#### Addendum No. 002

January 14, 2022

ODOT - Eaton Outpost DOT-200023

Prepared For: Ohio Department of Transportation / Ohio Facilities Construction Commission

TECHNOLOGY SITE UTILITY PLAN

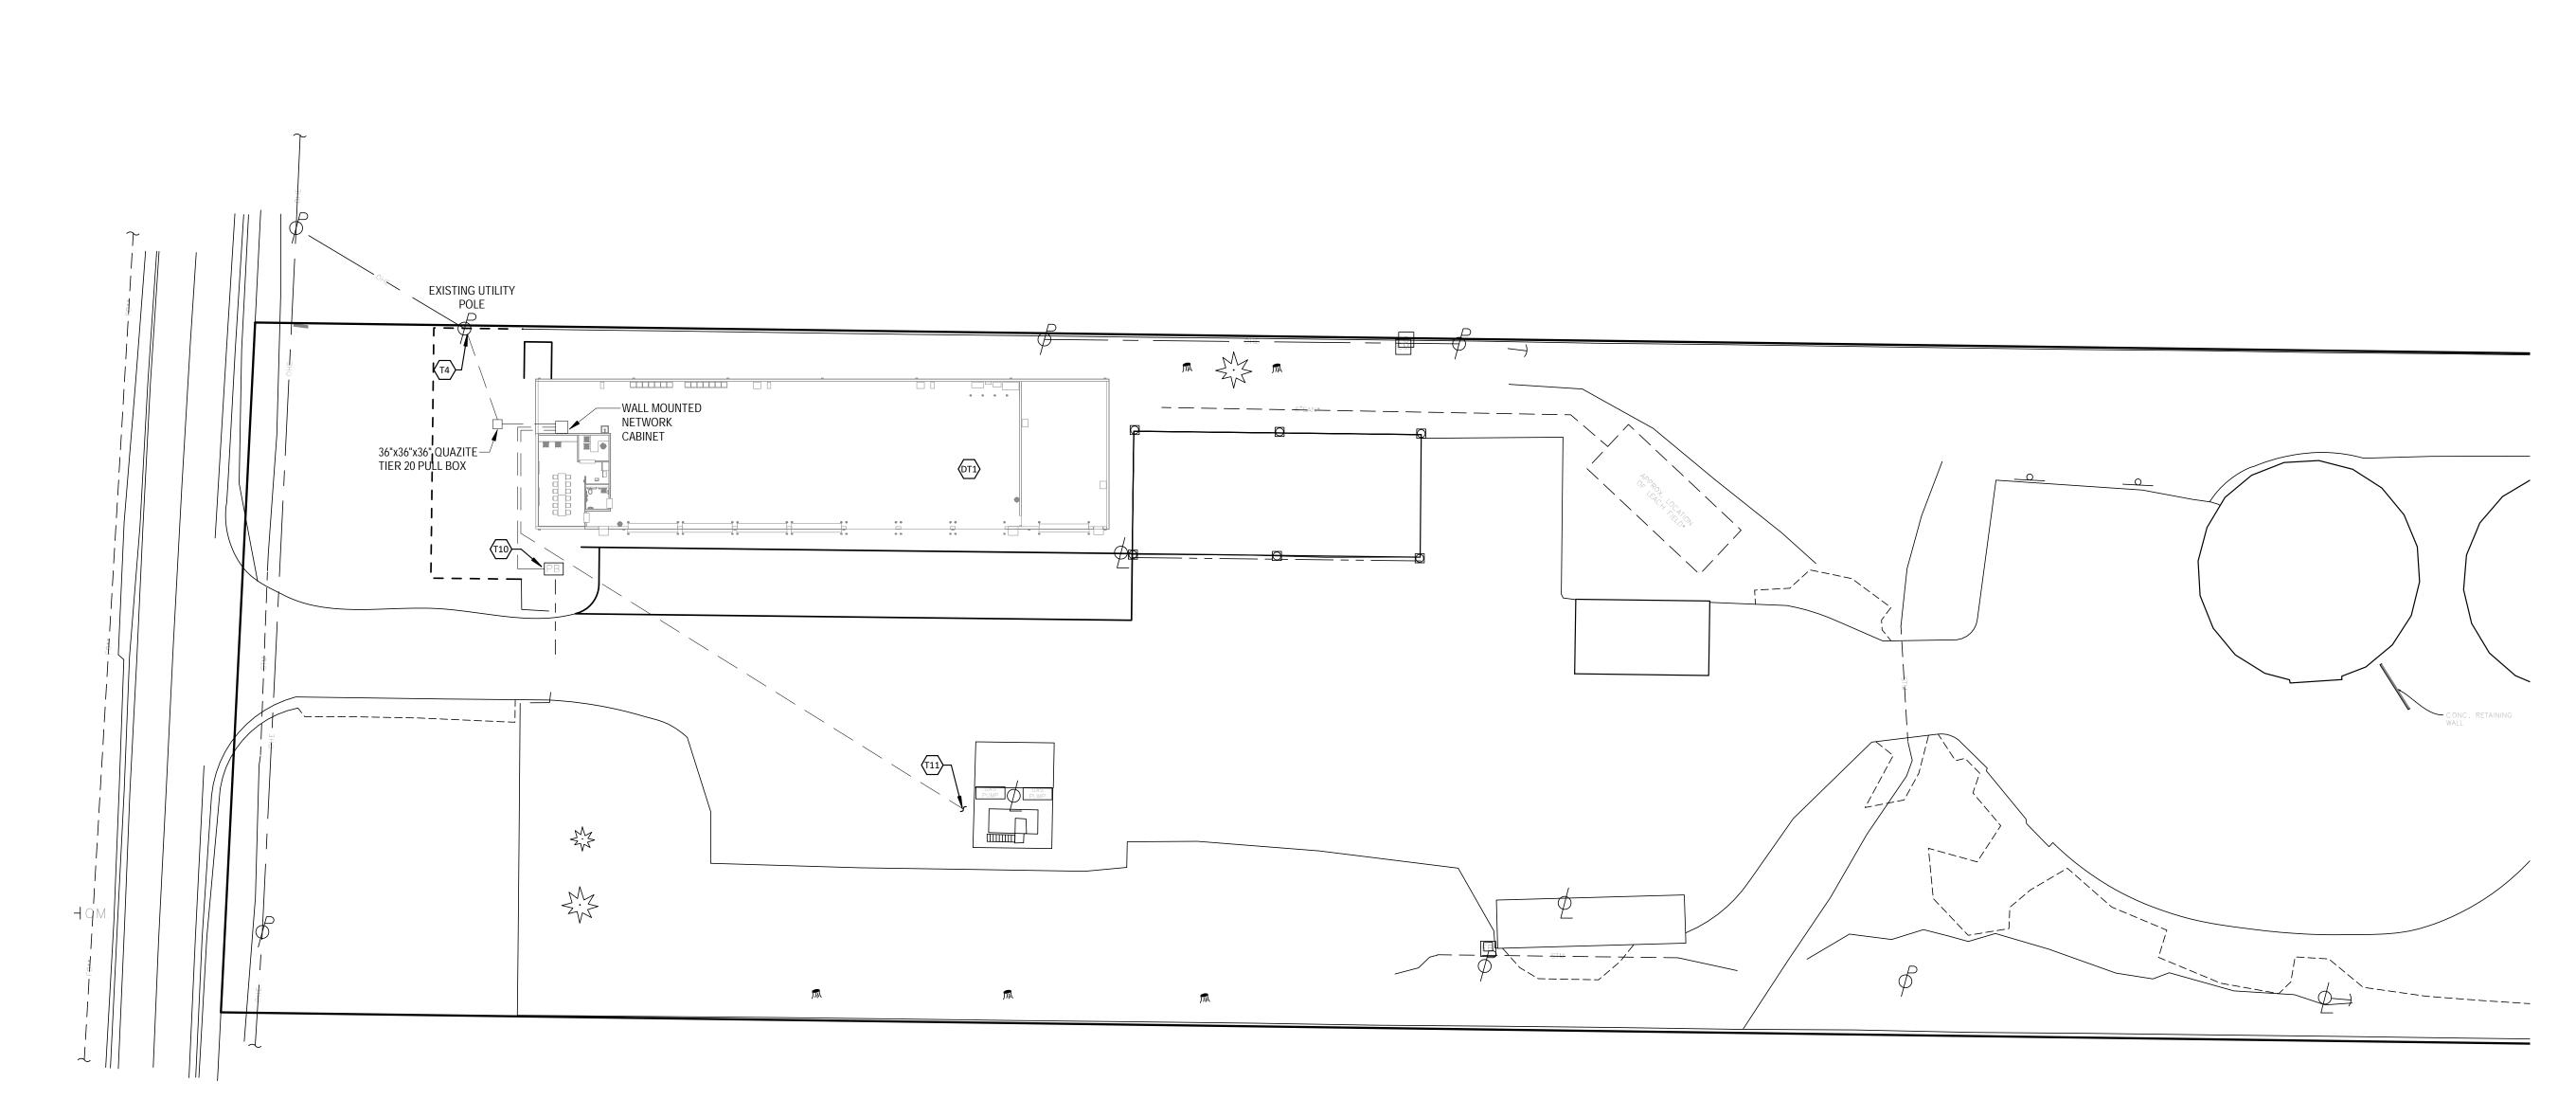
#### Revise Sheet TSU – TECHNOLOGY SITE UTILITY PLAN (Revised Sheet Attached)

Plan Note T10 – Revise note as clouded to remove requirement for wet rated Cat 6 cable to gate controller.

Plan Note T11 – Revise note as clouded to clarify conduit and cabling requirements for fuel island.

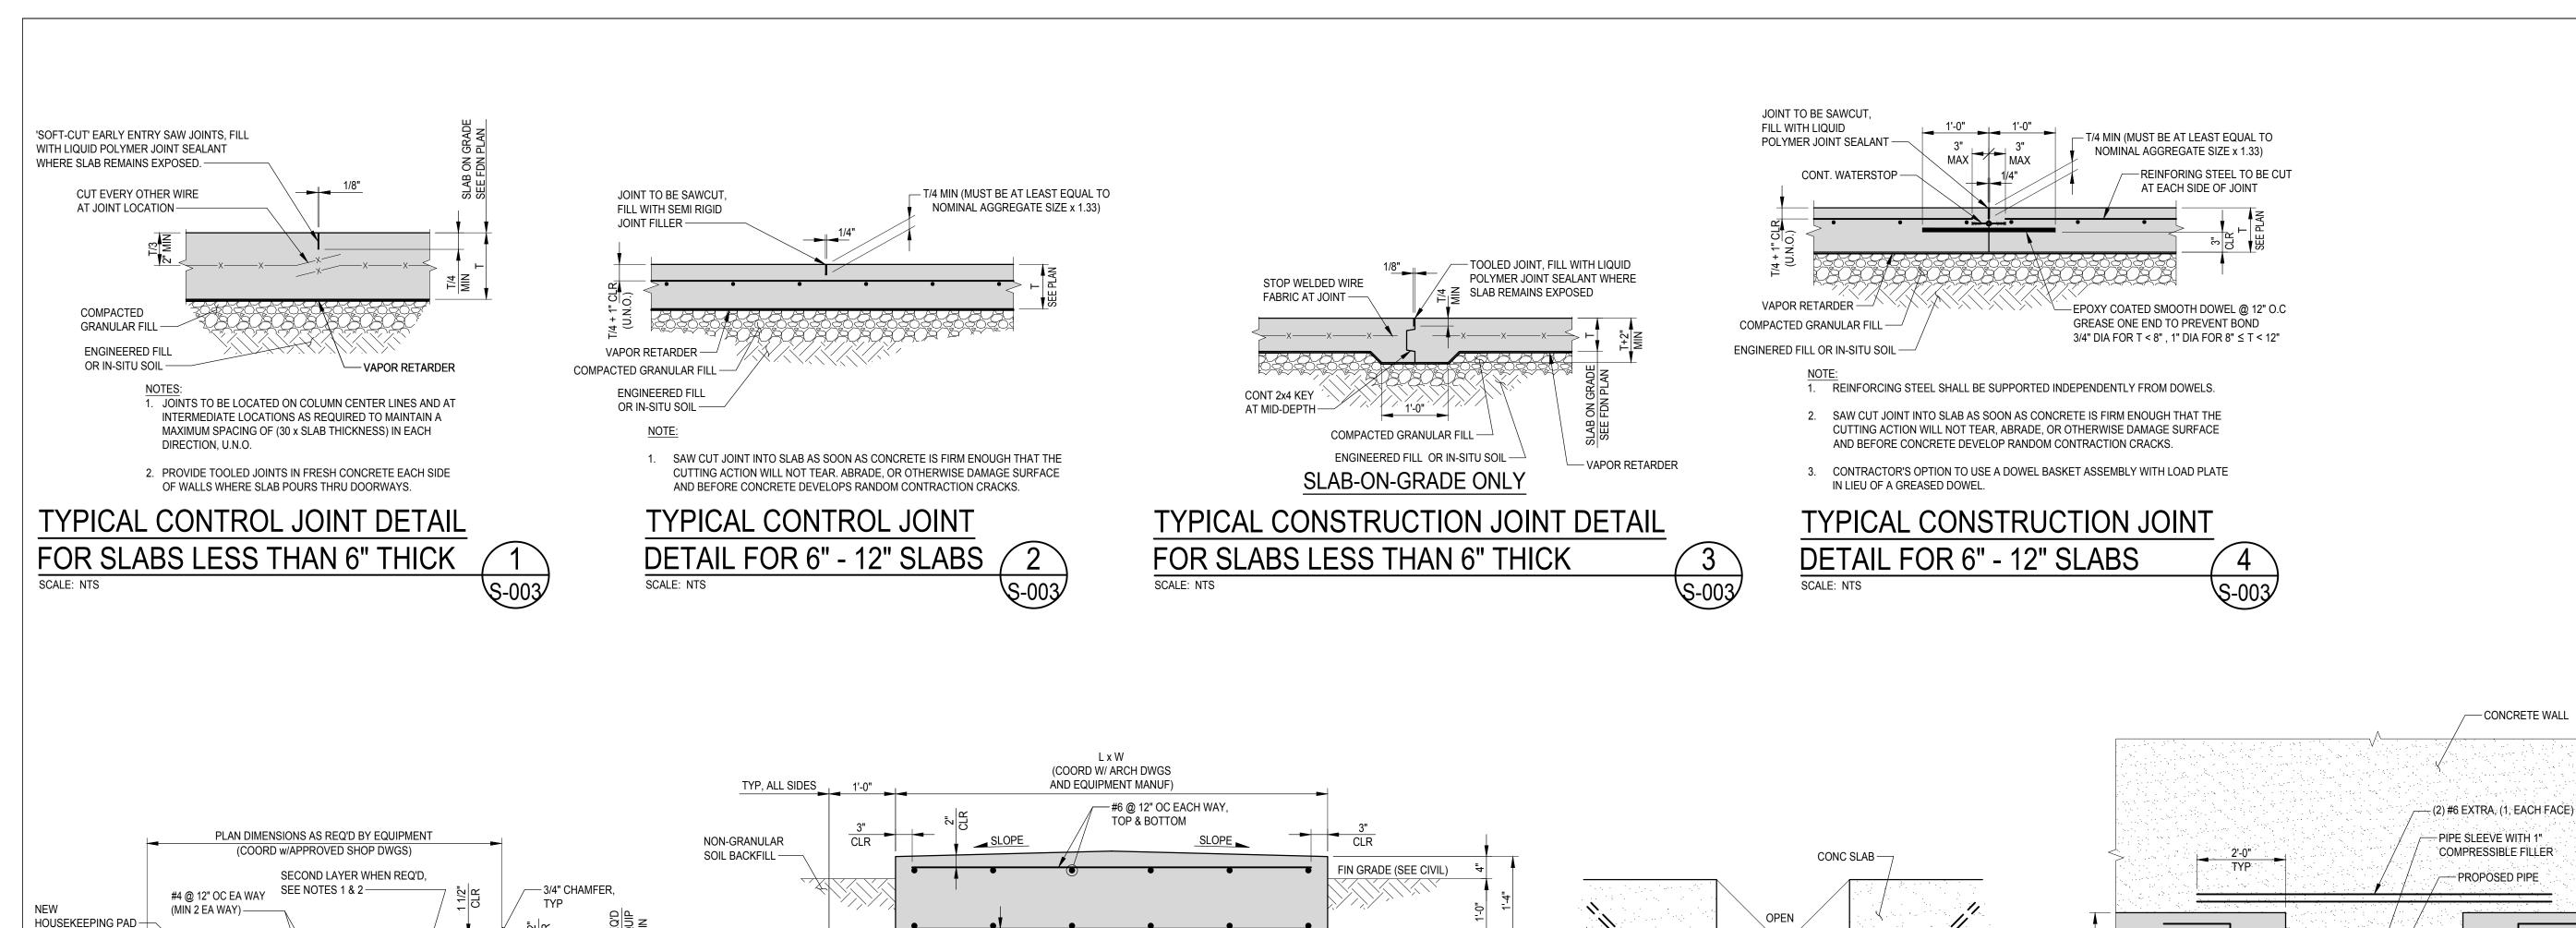
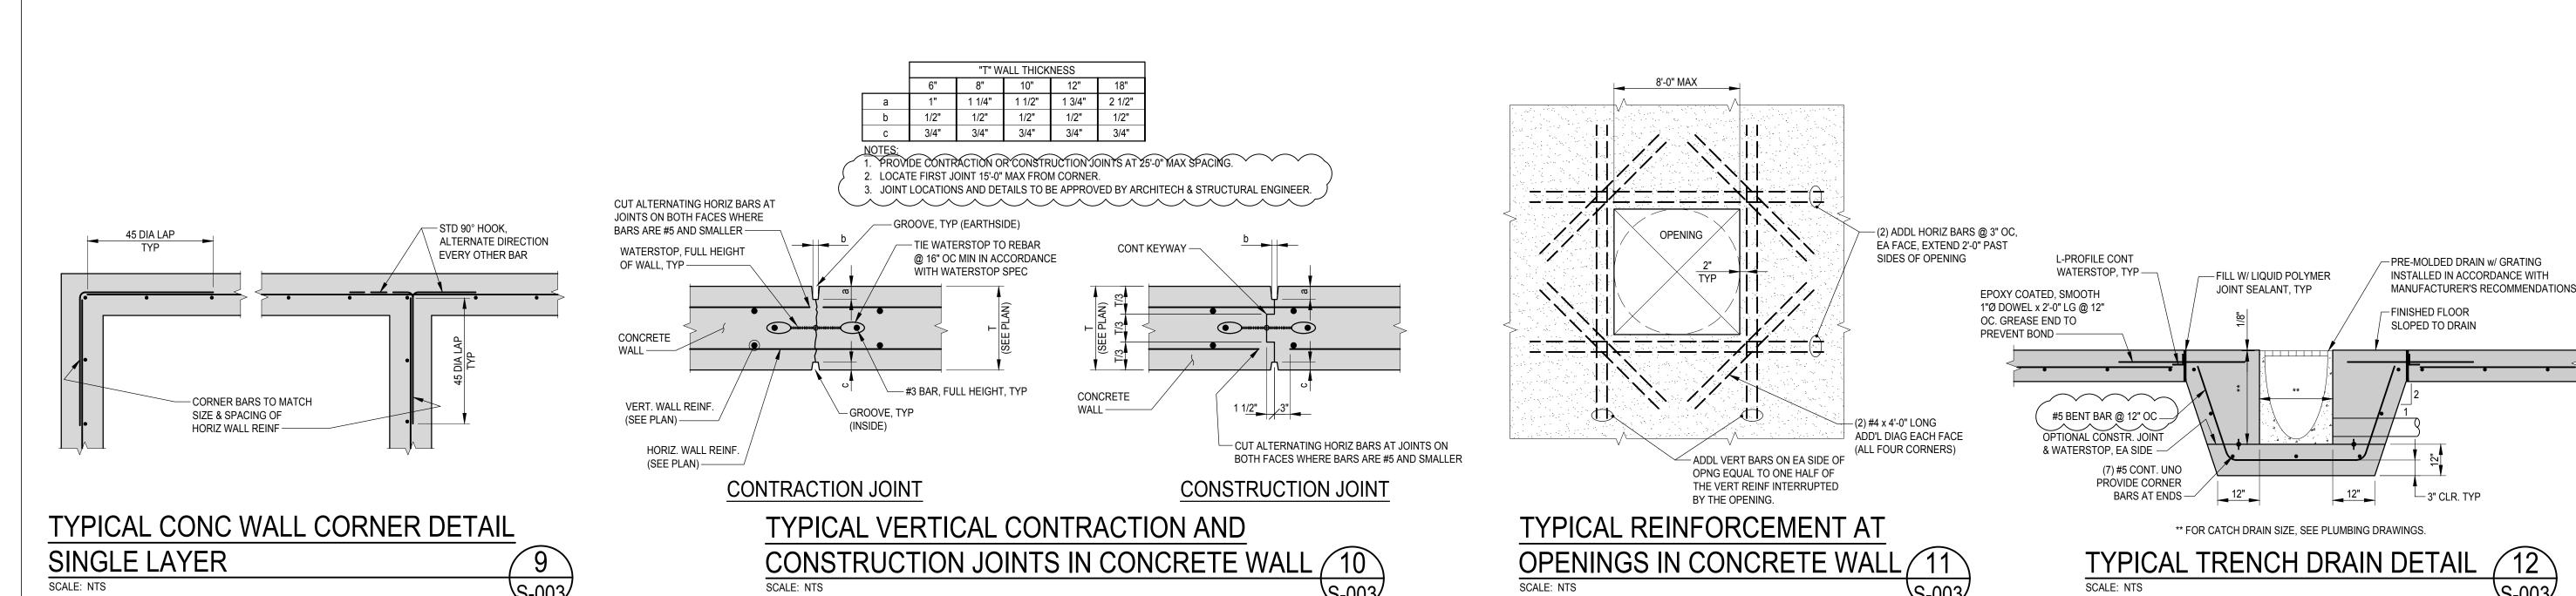
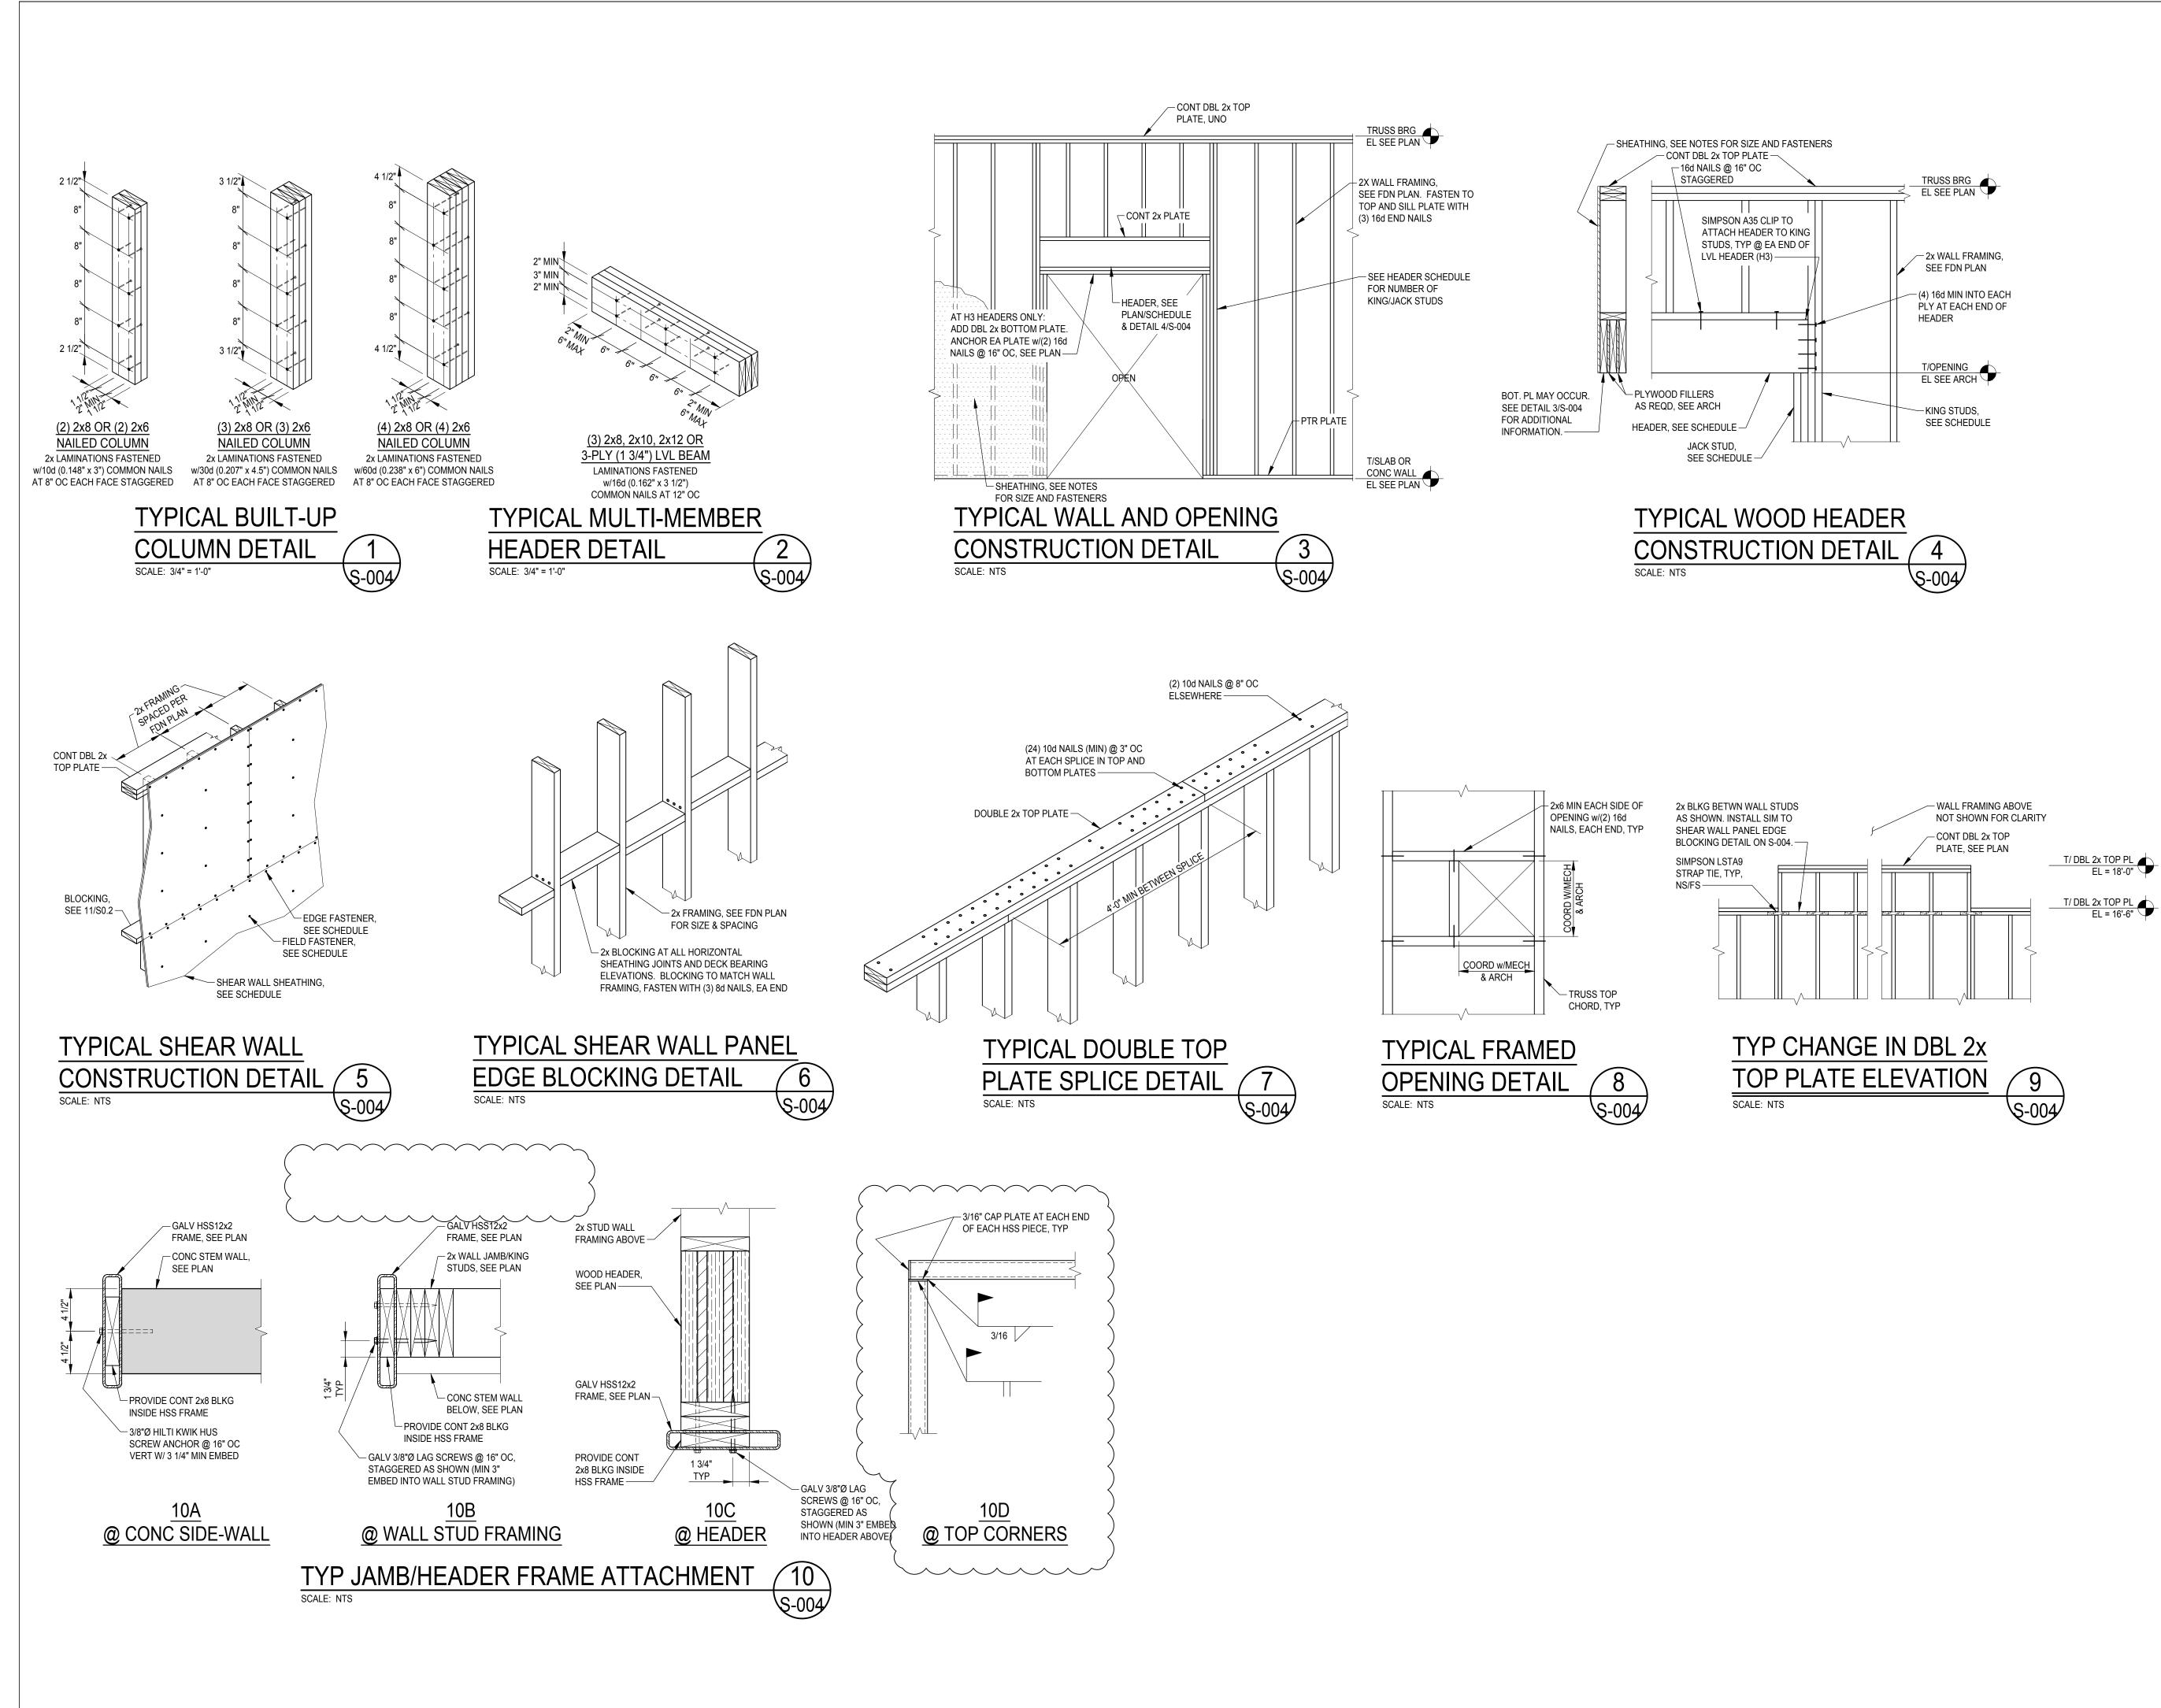
#### Revise Sheet S-003 – TYPICAL FOUNDATION DETAILS (Revised Sheet Attached)

Detail 10 – Revise notes as clouded. The following note has been <u>deleted</u>:

1. Vertical contraction and construction joints not permitted in shear walls.

Detail 12 – Note #5 bent bar spacing to be 12" o/c as clouded.
